PROJECT REVIEW COMMITTEE - CITY OF WILDWOOD

Agenda
Regular Meeting
July 9, 2024 10:00 AM
Commission Conference Room 124
100 N Main Street

- 1. PLAT 2304-003 Panda Express (Beaumont Lot 247) Replat
Parcel G04Q247**

2. **PLAT 2310-004 Turkey Run Replat Lots 4-9 & 12**

SHEET 2 OF 2

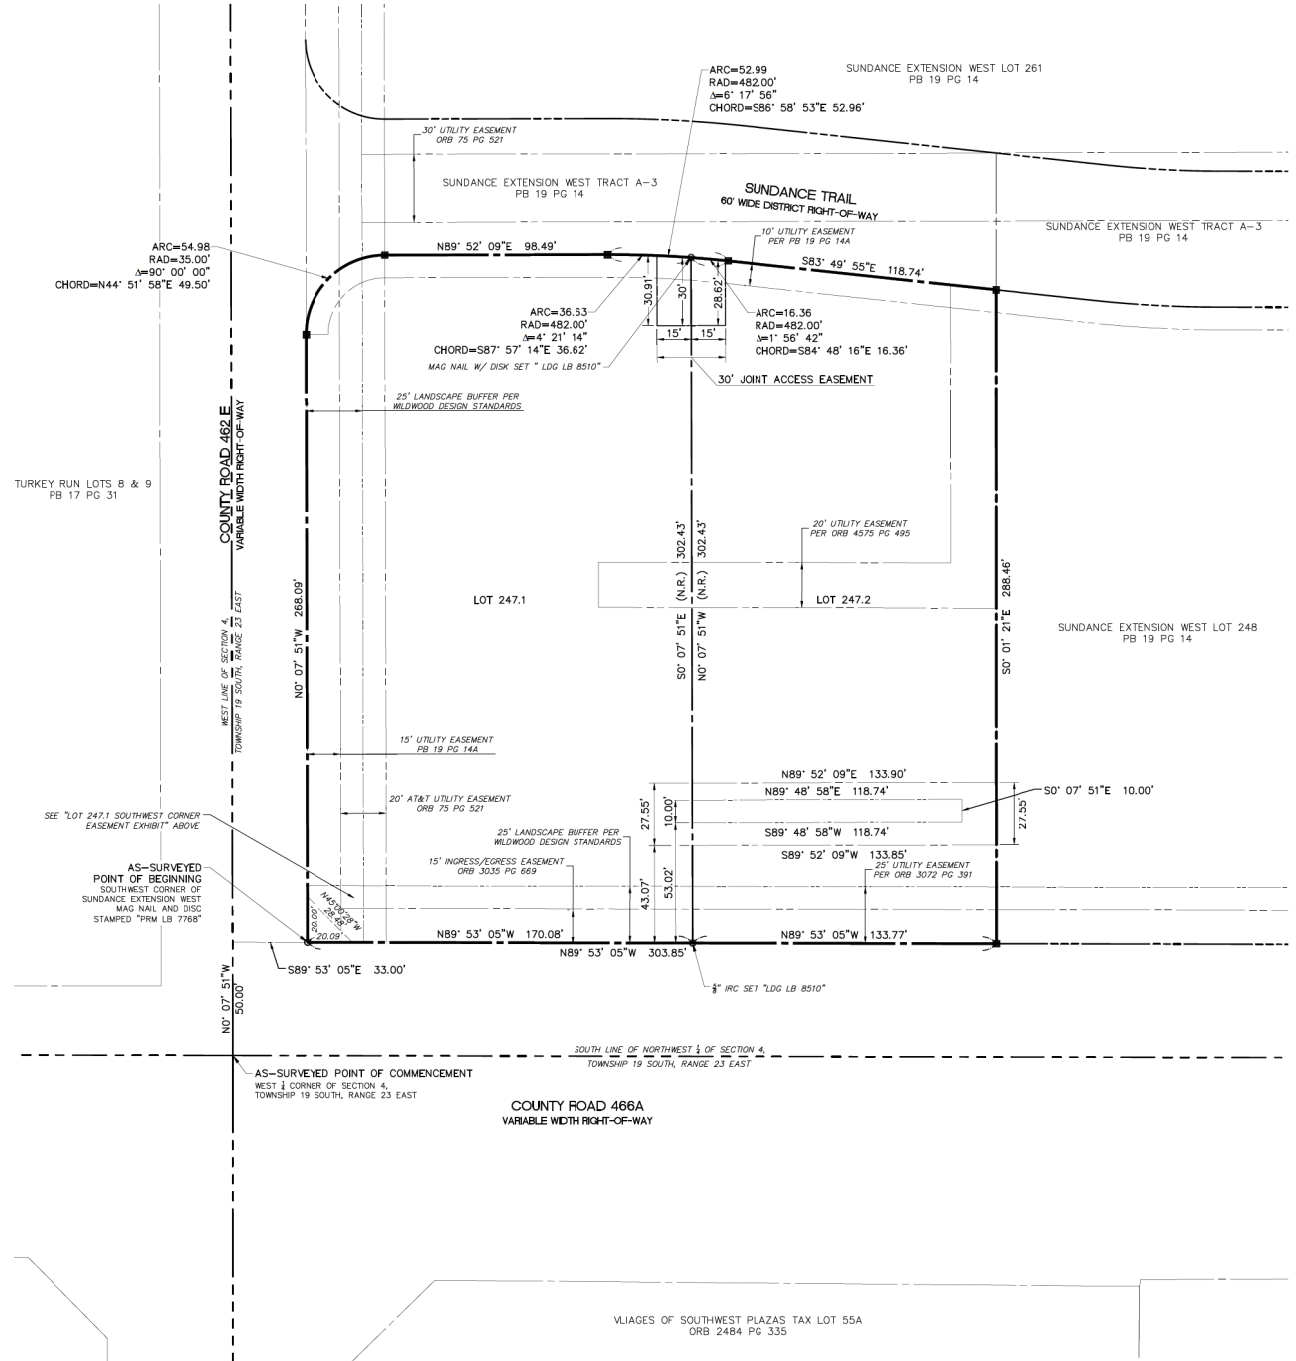
1. New Standing Comment: Provide executed easements at time of final plat adoption by Commission.
2. New Comment: Per new requirements of the Florida Statutes, please provide line for the address of the witnesses below Dedication and Grant of Easements.
Example provided below:
